APPLICATION NO.	FILING DATE	FIRST NAMED INVENTOR	ATTORNEY DOCKET NO.	CONFIRMATION NO.
10/789,980	03/02/2004	Masami Seto	R2180.0191/P191	9655
24998	7590	06/15/2005	EXAMINER	
DICKSTEIN SHAPIRO MORIN & OSHINSKY LLP			HO, TU TU V	
2101 L Street, NW			ART UNIT	
Washington, DC 20037			PAPER NUMBER	
			2818	
DATE MAILED: 06/15/2005

Office Action Summary

DETAILED ACTION

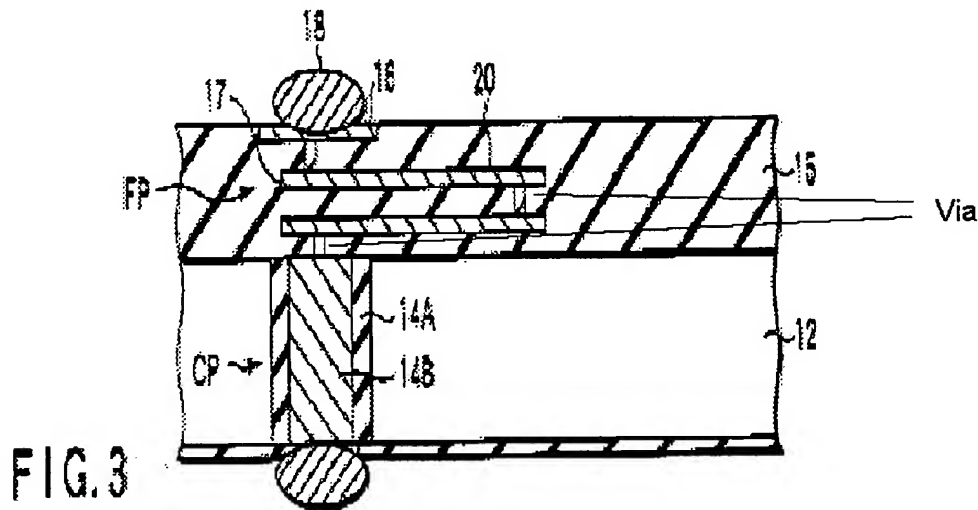
The '645 reference discloses in Figure 3 and respective portions of the specification a semiconductor device as claimed or substantially as claimed. In particular, the reference discloses a semiconductor device, comprising: a semiconductor substrate (12, paragraph [0038]: "semiconductor substrate 12") including main and back surfaces and a trimming opening (generally defined by CP or 14A/14B) penetrating therethrough from the back surface to the main surface; an insulating film (15) formed on the semiconductor substrate; and a fuse element (20, paragraph [0039]) formed in the insulating film at a position facing the trimming opening.

The reference further discloses wirings 17 and conductive vias in electrical communication with the fuse element 20.

In other words, the figure fails to clearly depict that the fuse element formed on the main surface of the semiconductor substrate through the insulating film as claimed in **claim 1**.

Note: "Via" is added by the examiner for ease of explanation

However, at the time the invention was made, it was known that conductive vias and wirings ("metalization lines") for semiconductor devices are formed by a process and structure more complicated than as depicted in Fig. 3.

In other words, at the time the invention was made, the fuse element 20 of the '645 reference simply could not be made in the insulating layer 15 as shown. To be specific, the lower level via and the lower level metal line of the '645 reference must be made in a separate insulating layer, similar to insulating layer 30, 32, or 34 of the Watanabe reference, and that the fuse element 20 must be made on that insulating layer, or in other words, the fuse is formed on the main surface of the semiconductor substrate through that insulating film, and yet in other words, the fuse is formed on the main surface of the semiconductor substrate through the insulating film as claimed. Thus the reference anticipates the claim.

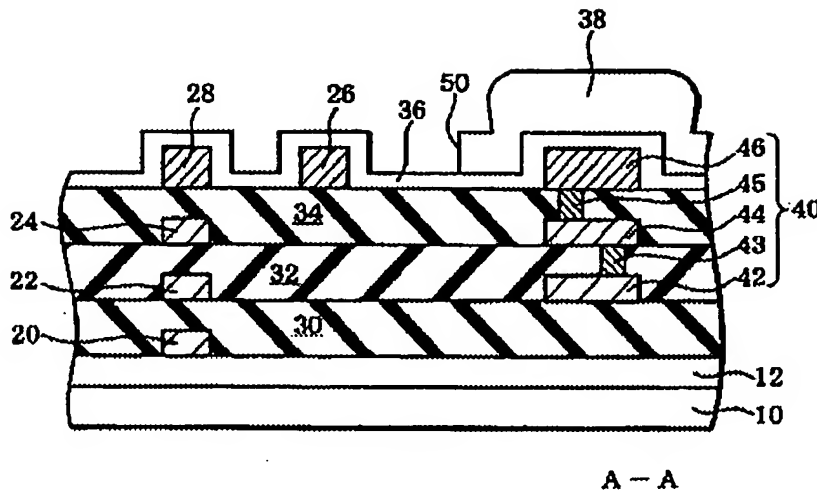
In particular and as an example, at the time the invention was made, a semiconductor device having a fuse (26), metal lines (20,22,24,42,44) and vias (43,45) is disclosed by Watanabe U.S. Patent Application Publication 20030085445.

Specifically, Watanabe discloses that the fuse element (26) is formed on the main surface of the semiconductor substrate through the insulating film (30/32/34), and that metal lines of different levels and vias of different levels are formed from different insulating layers (30, 32, 34).
